<b>APPLICABLE TO:</b>	
PUBLICATION NO.	<u>NEDO-24229-1</u>
T. I. E. NO.	<u>80NED270</u>
TITLE	<u>Peach Bottom Atomic Power</u>
	<u>Station Units 2 and 3 Single-</u>
	<u>Loop Operation</u>
ISSUE DATE	<u>May 1980</u>

## ERRATA And ADDENDA SHEET

NO.	<u>2</u>
DATE	<u>June 1984</u>
<i>NOTE: Correct all copies of the applicable publication as specified below.</i>

Figure 5-1. Peach Bottom 2 Suction Break Spectrum Reflood Times

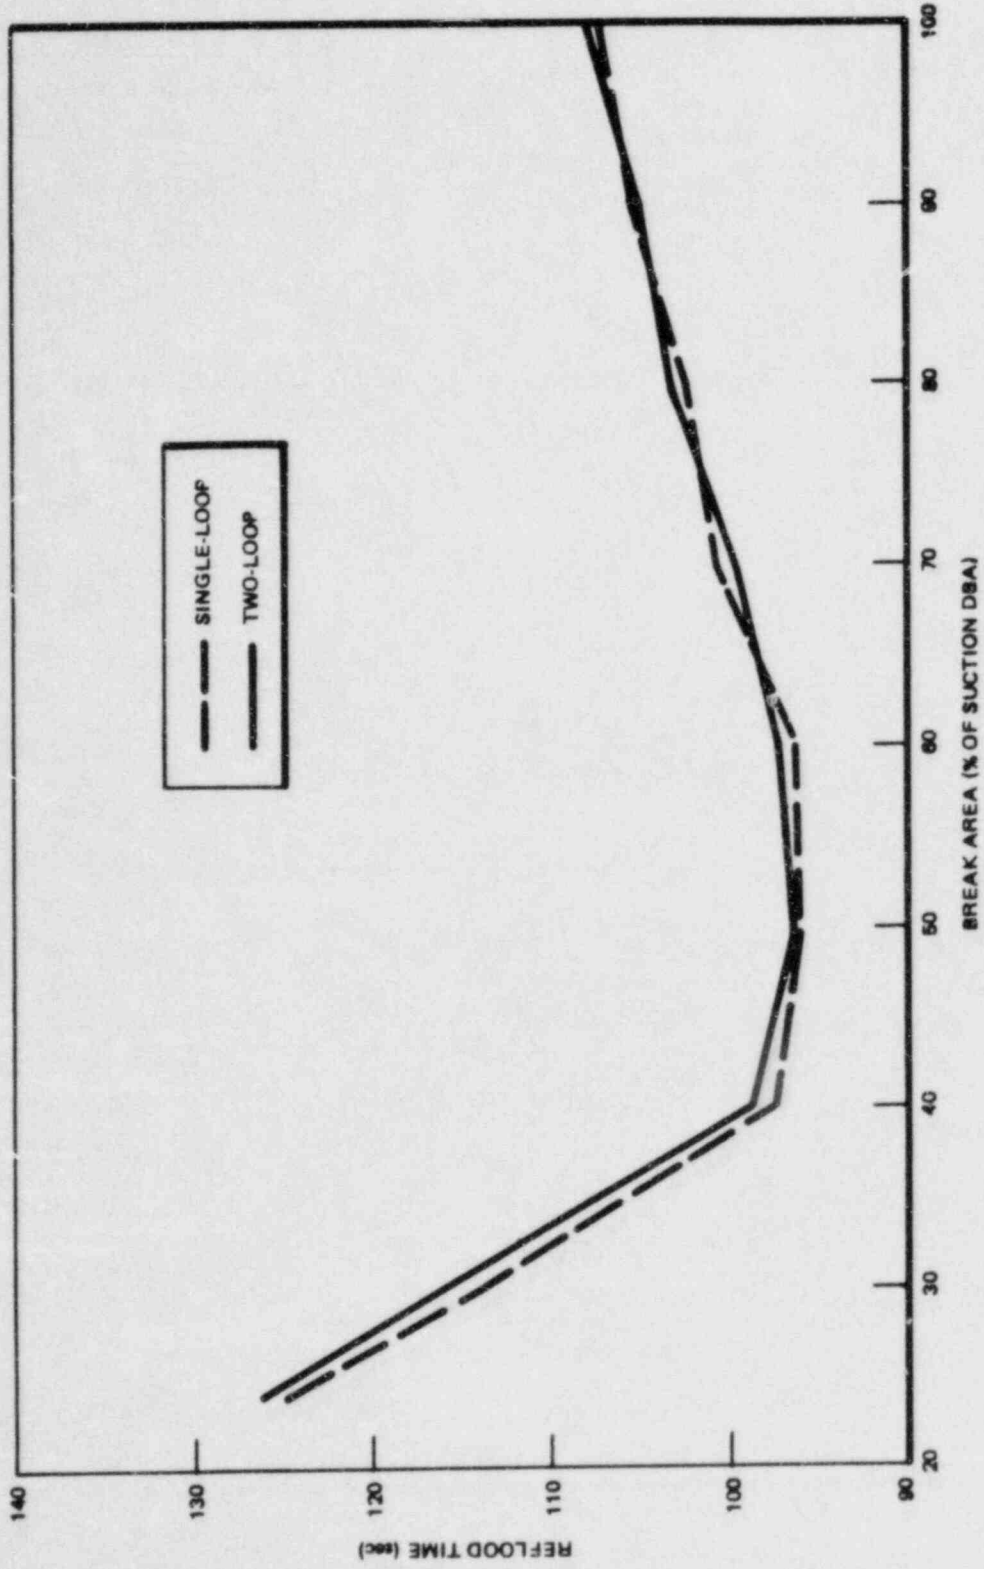
ITEM	REFERENCES (SECTION, PAGE PARAGRAPH, LINE)	INSTRUCTIONS (CORRECTIONS AND ADDITIONS)
1.	Page 5-5	Replace with new page 5-5.  (Change bars in right-hand margin indicate where report has been revised.)
